QUALITY ASSURANCE -- NON-CONFORMANCE REPORT

Report No: NCR-000277

Job Name: SAS Superstructure

Subject: NCR No. ZPMC-0251

Reference Description: South Tower, 135m Diaphragm inadequate pre-heat

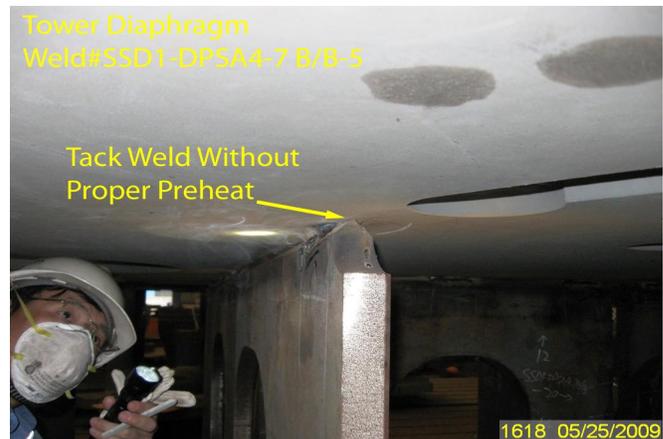
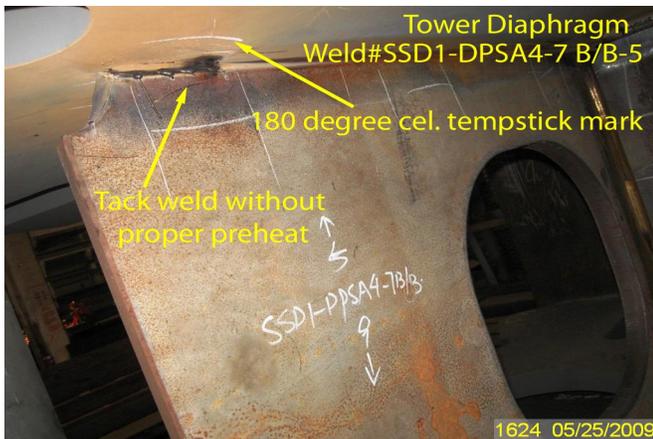
QA observed tack welding without adequate pre-heat on tower diaphragm weld joint SSD1-DPSA4-7 B/B-5. The recorded temperature at the tack weld and adjacent base material was 100 degrees Celcius. The required pre-heat temperature according to approved WPS is 180 degrees Celcius.

WPS-B-T-33(1)14-SMAW-4G Tack Weld

AWS D1.5-2002 Section 3.3.7.1 "Tack welds shall be subject to the same quality requirements as final welds"

Propose a resolution for the identified non-conformance including documentation that the tack welds placed are in compliance with the contract requirements. In addition to the material/workmanship non-conformance, propose a resolution that addresses the failure of Quality Control to identify the lack of preheat of the base material. Provide documentation of the steps taken by the Quality Control Manager to prevent future occurrences.

Please provide documentation of the weld repairs that were performed and that the repairs were acceptable. The Department will review the Contractor's proposal to close Non-Conformance ZPMC-0251 at that time.

The Non-Destructive Testing (NDT) for this weld should be at least 72 hours after welding to ensure that there are no delayed cracks from any possible hydrogen contamination.

Reference Description: South Tower, 135m Diaphragm inadequate pre-heat

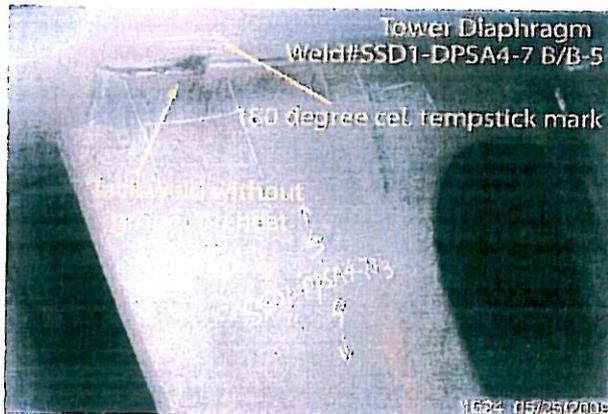
QA observed tack welding without adequate pre-heat on tower diaphragm weld joint SSD1-DPSA4-7 B/B-5. The recorded temperature at the tack weld and adjacent base material was 100 degrees Celcius. The required pre-heat temperature according to approved WPS is 180 degrees Celcius.

WPS-B-T-33(1)14-SMAW-4G Tack Weld

AWS D1.5-2002 Section 3.3.7.1 "Tack welds shall be subject to the same quality requirements as final welds"
